工程指示 / 要求簡箋(E.I.)

工程指示編號：EI / 8779 / 25

工程名稱：將軍澳日出康城 11

工程項目：幕牆浴室 T1-T3 AB 單位 橫料加做鋁板 地盤用

唧胶示意图

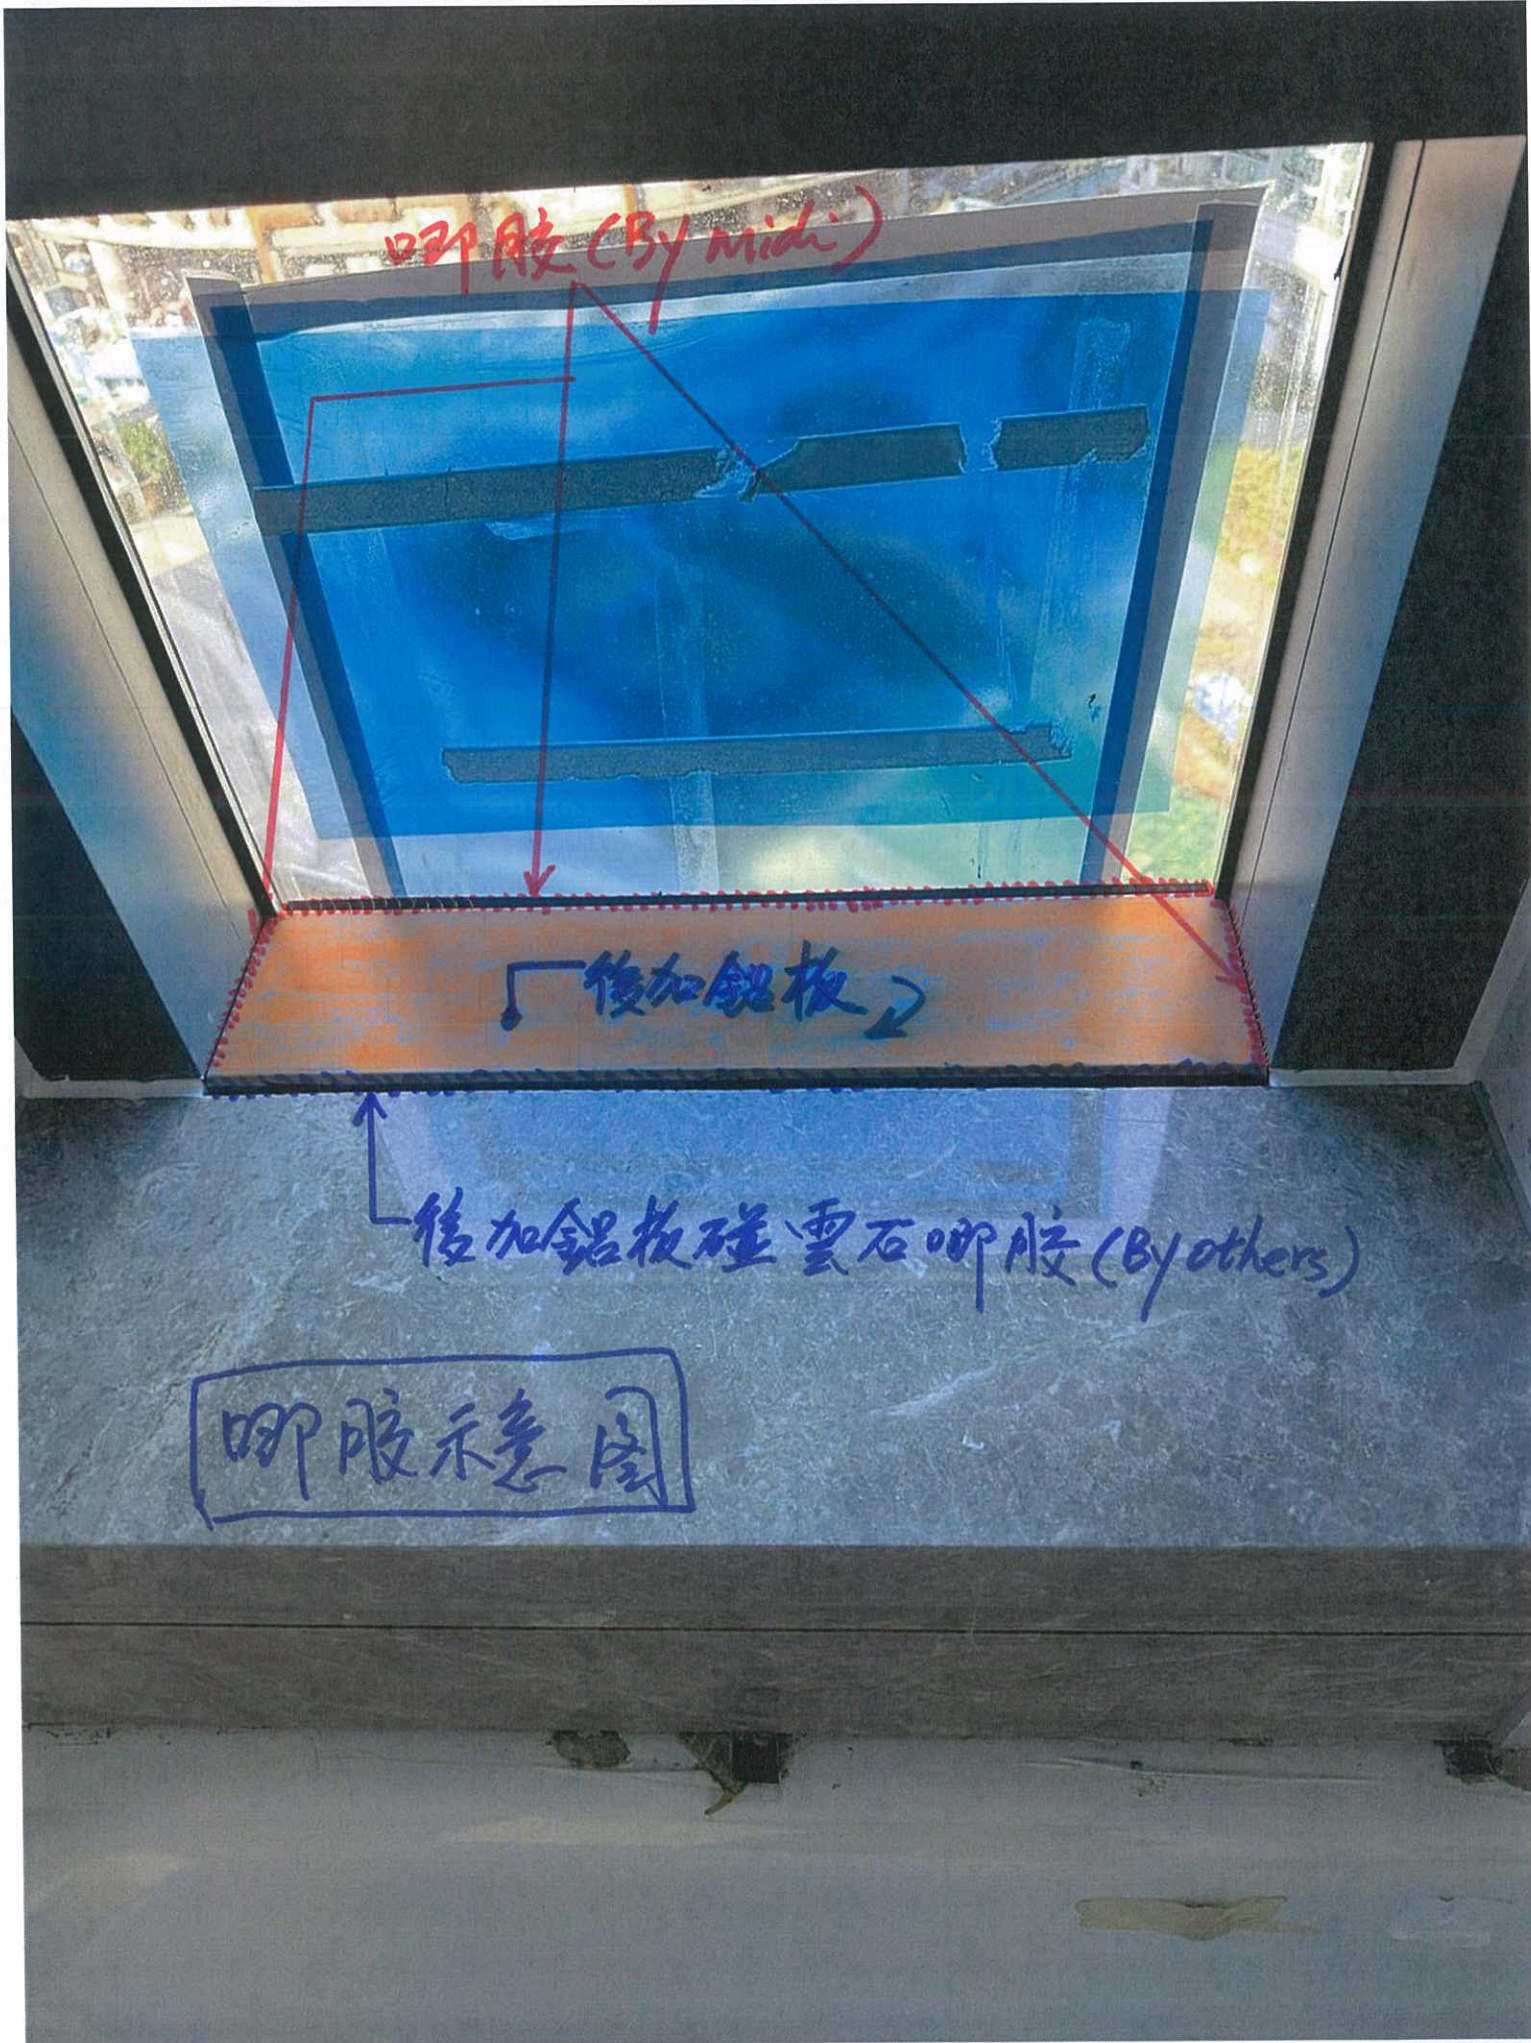
一楼加铝板

唧胶 (By midi)

後加鋁板

後加鋁板碰雲石唧胶 (By others)

10/F, 12/E, 15/F-23/F, 25/F-33/F,
 35/F-39/F, 41/F-43/F, 45/F-53/F,
 55/F-63/F & 65/F-66/F
 第2座 (2A) 及 第2座 (2B)
 10樓、12樓、15樓至23樓、
 25樓至33樓、35樓至39樓、
 41樓至43樓、45樓至53樓、
 55樓至63樓及65樓至66樓
 樓面平面圖

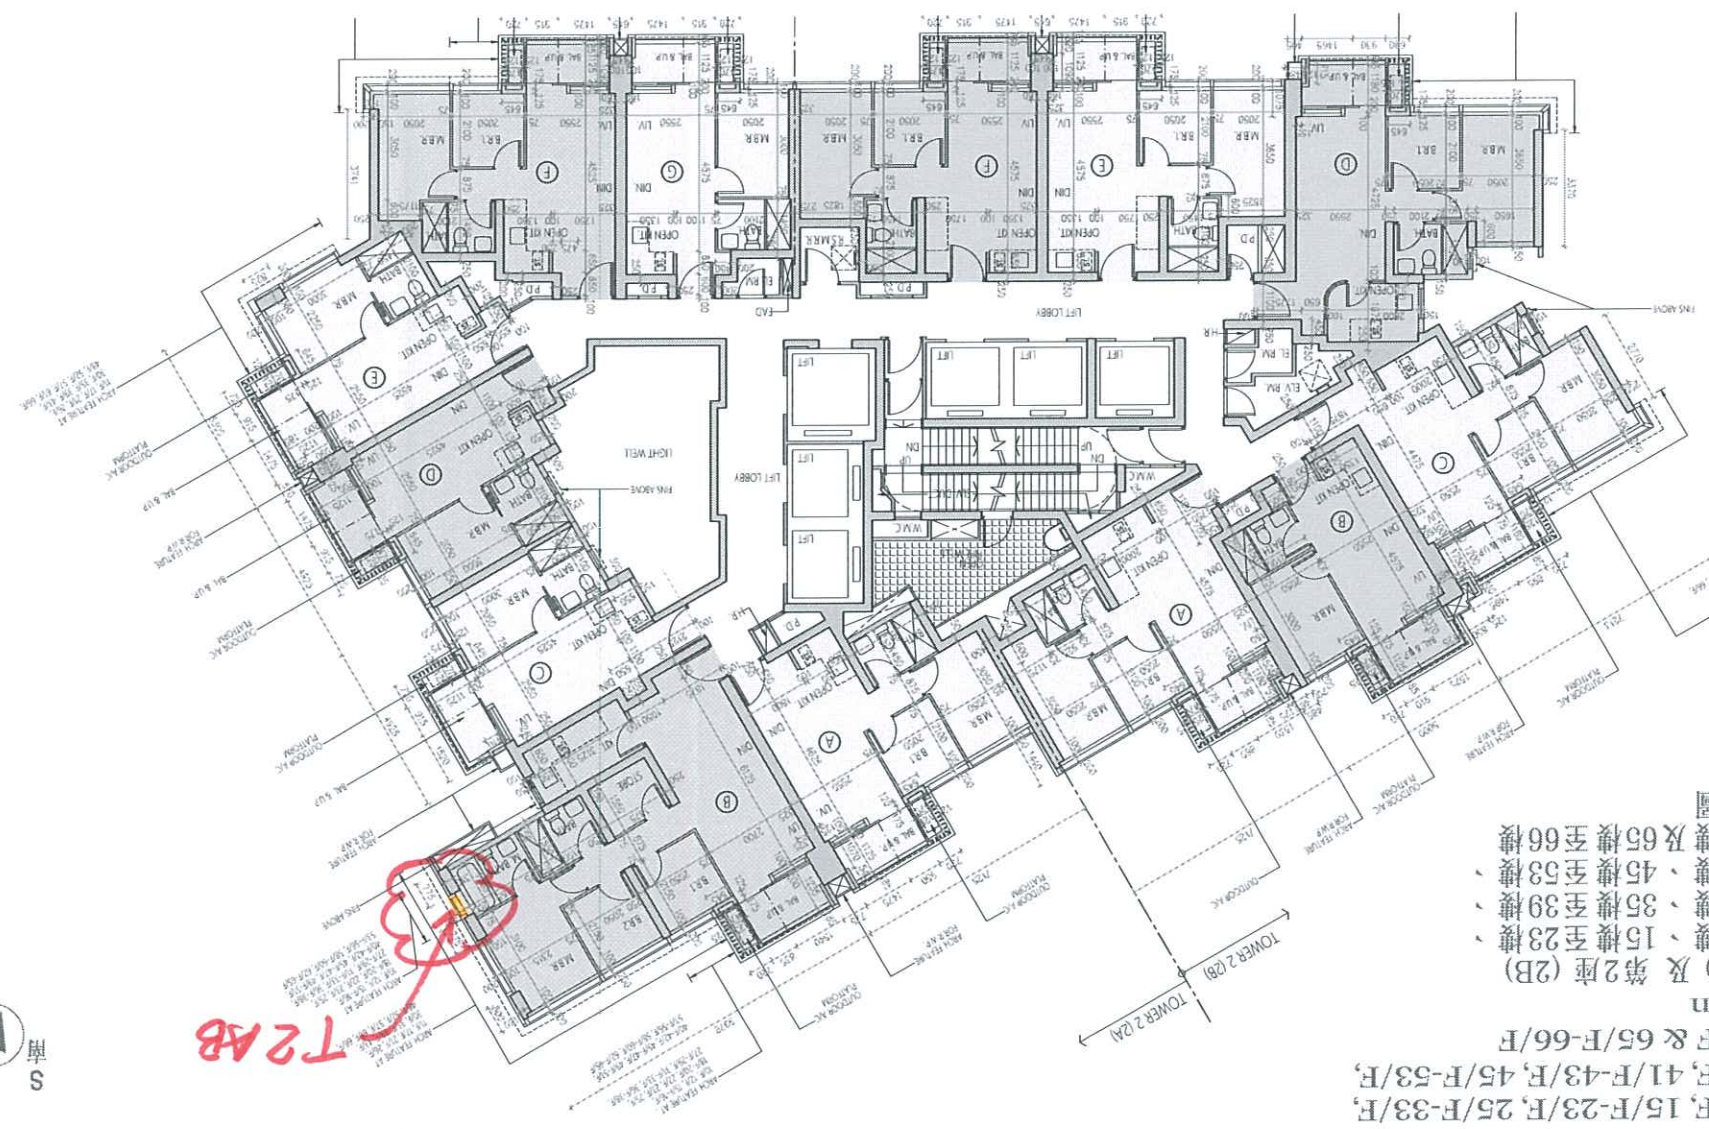
T2AB

10/F, 12/F, 15/F-23/F, 25/F-33/F,
 35/F-39/F, 41/F-43/F, 45/F-53/F,
 55/F-63/F & 65/F
 Floor Plan
 第3座 (3A) 及 第3座 (3B)
 10樓、12樓、15樓至23樓、
 25樓至33樓、35樓至39樓、
 41樓至43樓、45樓至53樓、
 55樓至63樓及65樓
 樓面平面圖

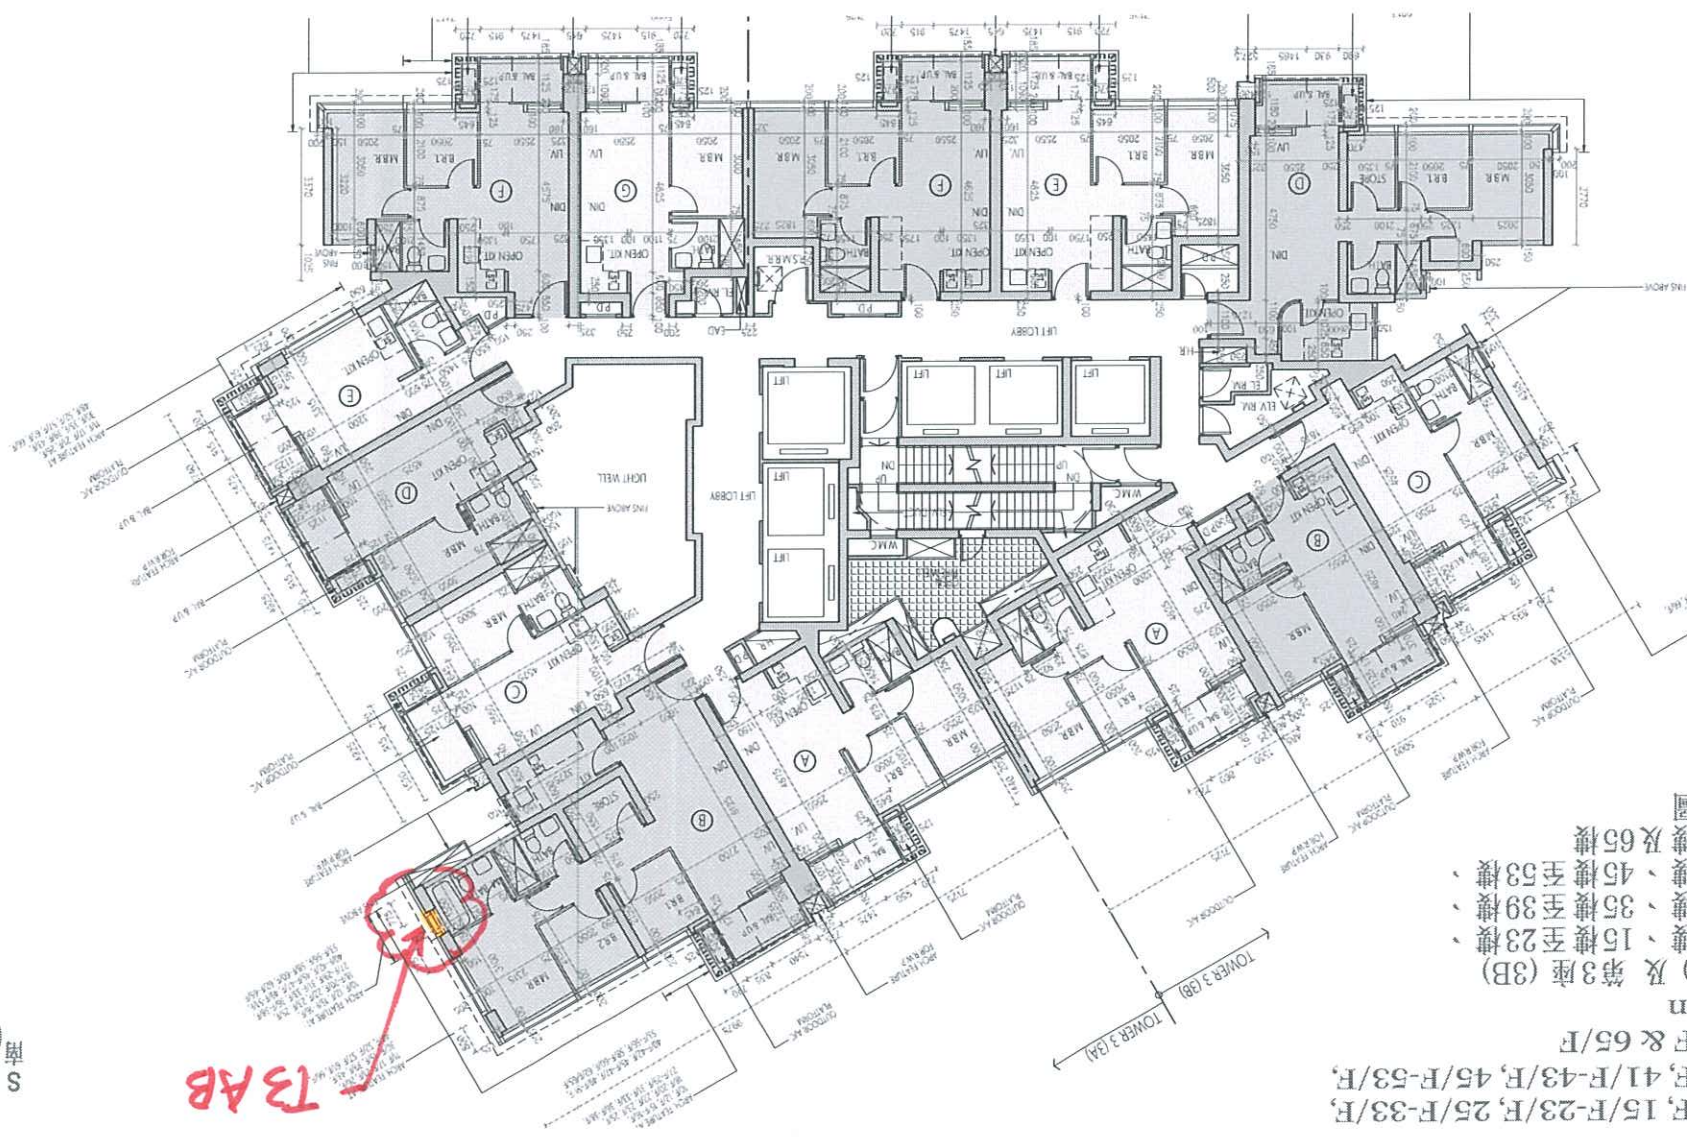
T3 AB
